Re: Firehouse Plaza - Parking Revisions Submission Materials List

Re: Firehouse Plaza - Parking Revision to Site Plan Amendment

Firehouse Plaza

30-Scale Site Plan

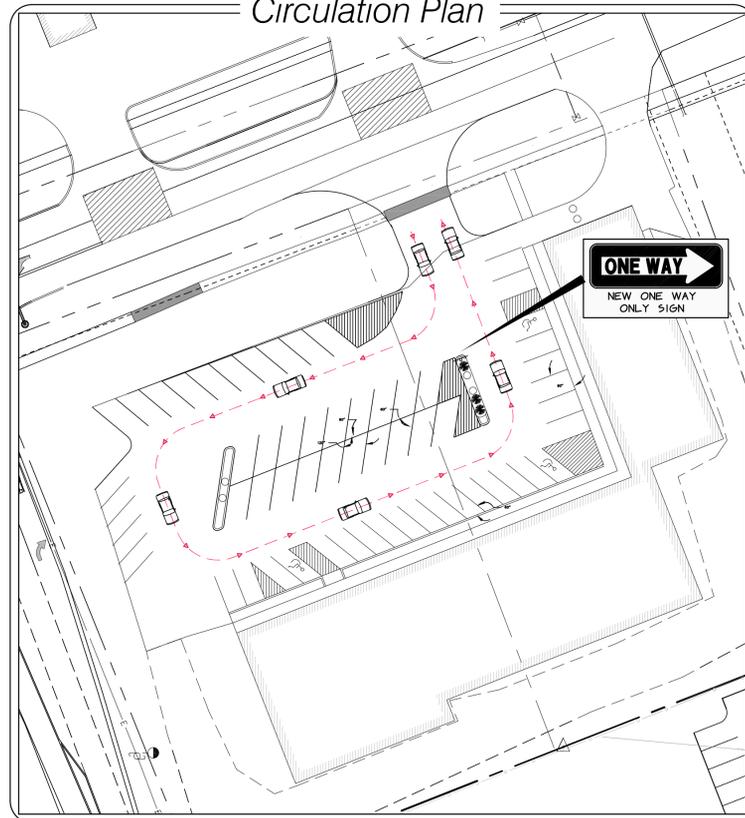
Sheet 1 "30-Scale Site Plan" shows the following revisions:

- Increased parking by a net of 7 spaces. Added row of parking along northern edge of pavement and removed some internal spaces.
- Shifted middle rows of parking south and reconfigured islands to improve circulation.
- Added landscaping along north and west sides of parking lot.
- Slightly widened new access to accommodate turning trucks.

Ten new parking spaces are being proposed along the northern edge of the parking lot. These will be located entirely within the existing paved area and will not increase impervious area. Three spaces within the existing parking area will be removed as a result, to allow for circulation. The northwest corner of the parking lot will be reclaimed,

seeded, and mulched; this will likely also be a good location for snow storage. The flow and quality of stormwater from the site will not be altered by this revised layout; the landscaping at the perimeter of the lot has been configured to ensure proper drainage and flow from the pavement to the swale.

Per the Hinesburg Zoning standard 4.3.8, we have added 40 shrubs to the perimeter of the parking lot. This landscaping is being added in lieu of a landscape island within the new row of ten spaces to reduce conflicts for snow plowing, while still providing screening. We are also proposing 11 shrubs in the landscape islands interior to the parking lot; 7 of these are replacements and 4 are new plants to augment the interior landscaping. The total estimated construction cost of this project is \$21,000 and the total additional landscaping budget (not including the 7 interior island replacement plantings) is \$3,225 (which well exceeds the 3% minimum required).

**Proposed Circulation Plan**

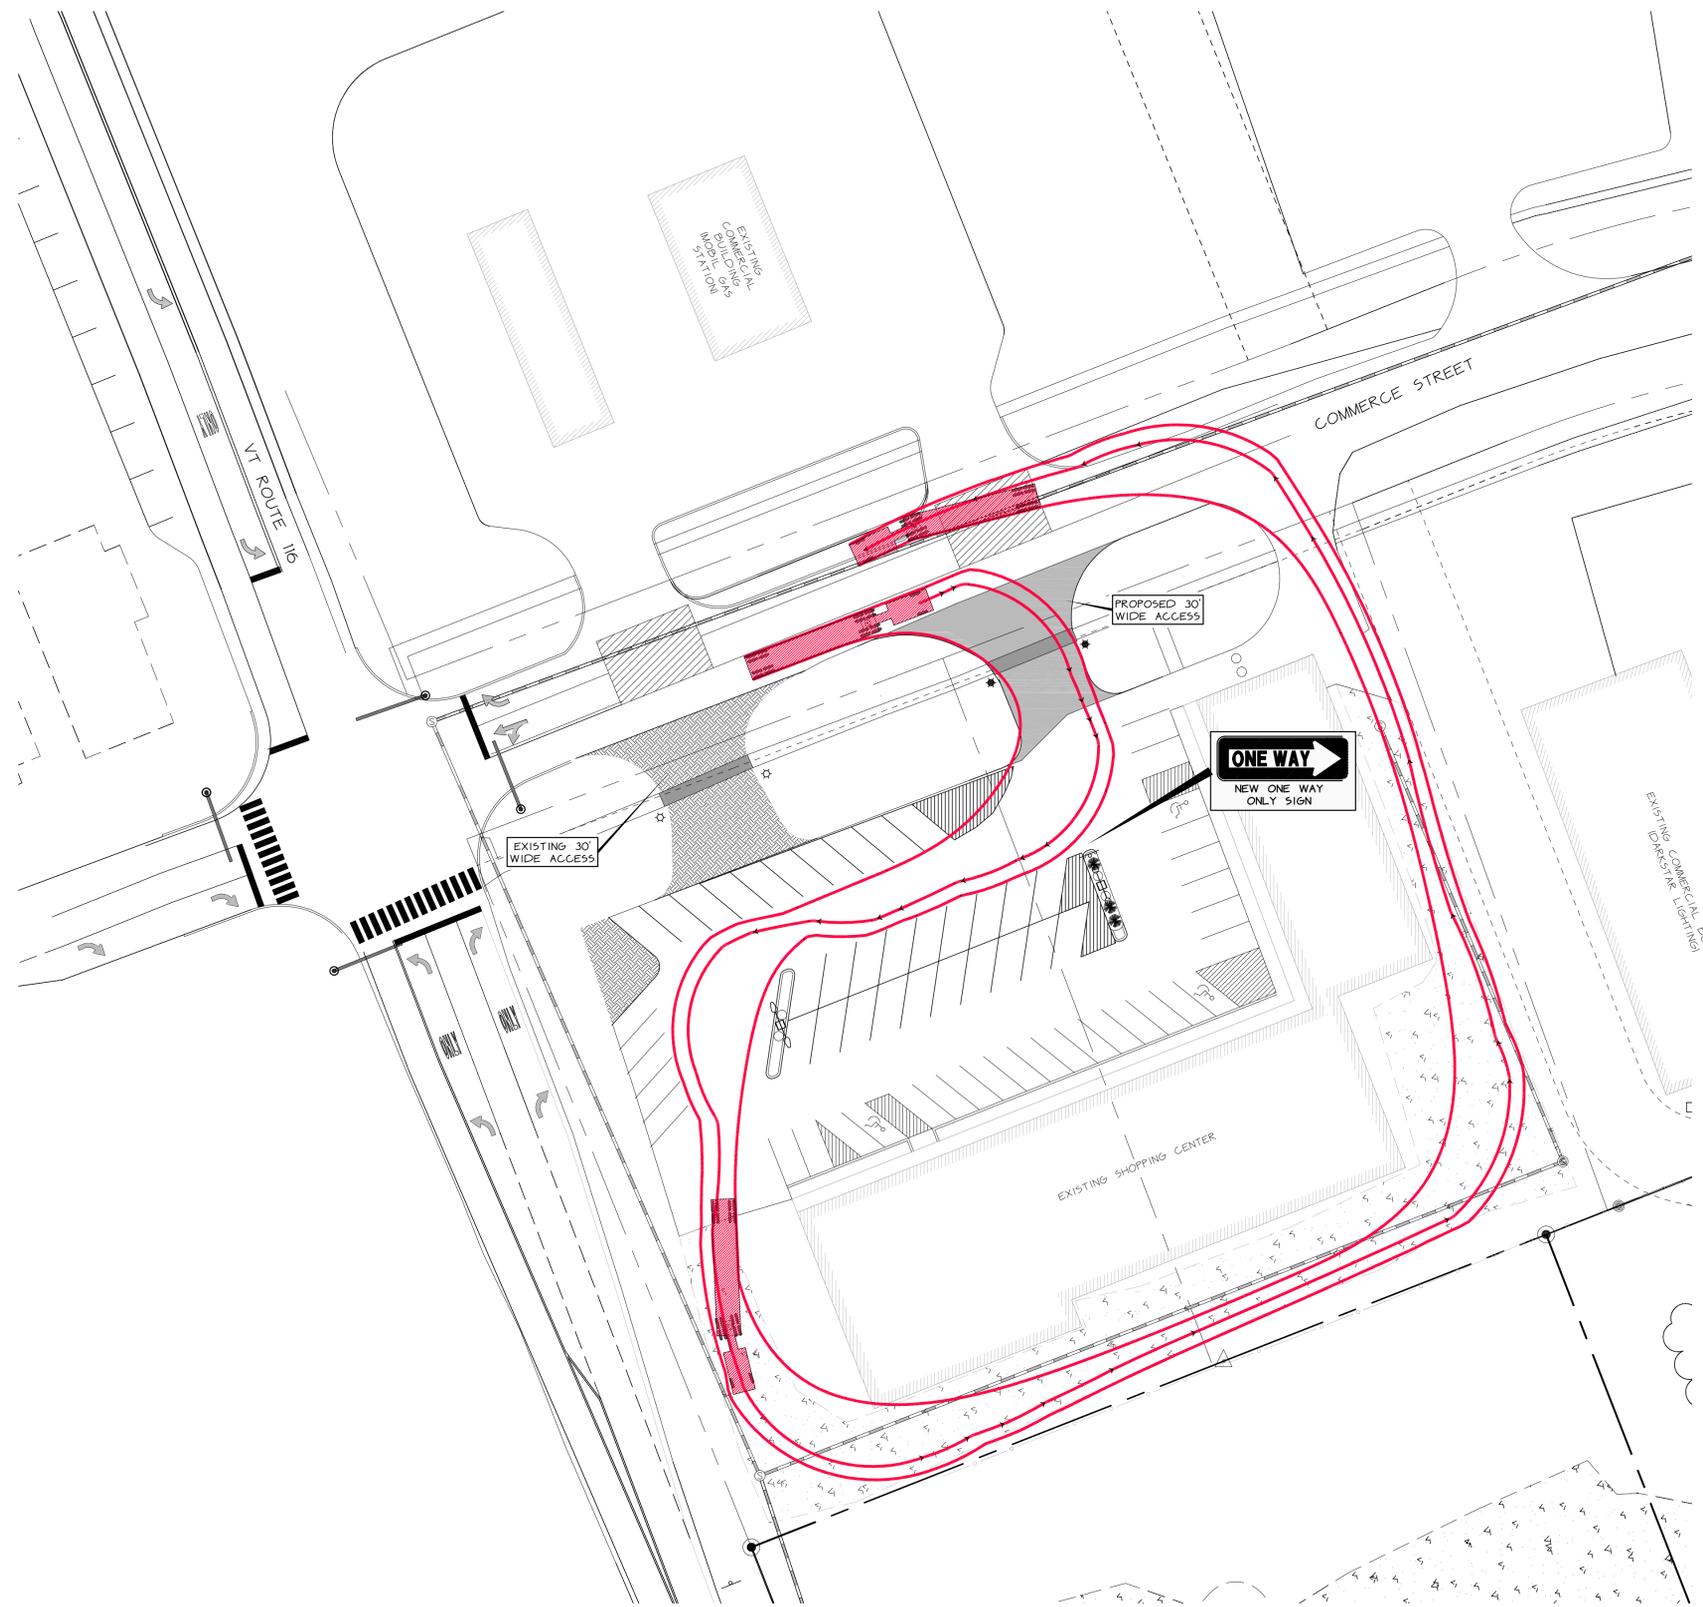
Sheet 3 "Circulation Plan" shows how tractor trailers will circulate counter-clockwise through the parking lot. It should be noted that this is a very conservative turning template, so most trucks will not require that space, but the site has been planned accordingly. As was mentioned in the materials of 2/24/14, the full size trucks that use this site (WB-62s) will swing into the exiting lane when entering the site. This is no different than the current access - as is shown on the attached Sheet 4 "Existing Circulation Plan." By relocating the access, current circumstances will improve because traffic queuing behind the truck waiting for cars to exit the site will queue on Commerce Street and not immediately back up onto Route 116. It is common for trucks to make wide entrances into sites and it is prudent not to overbuild these intersections for the occasional conflict. A 30' wide access is more than sufficient and is a typical access width. We are proposing to slightly widen the western turning radius into the access to ease this turn.
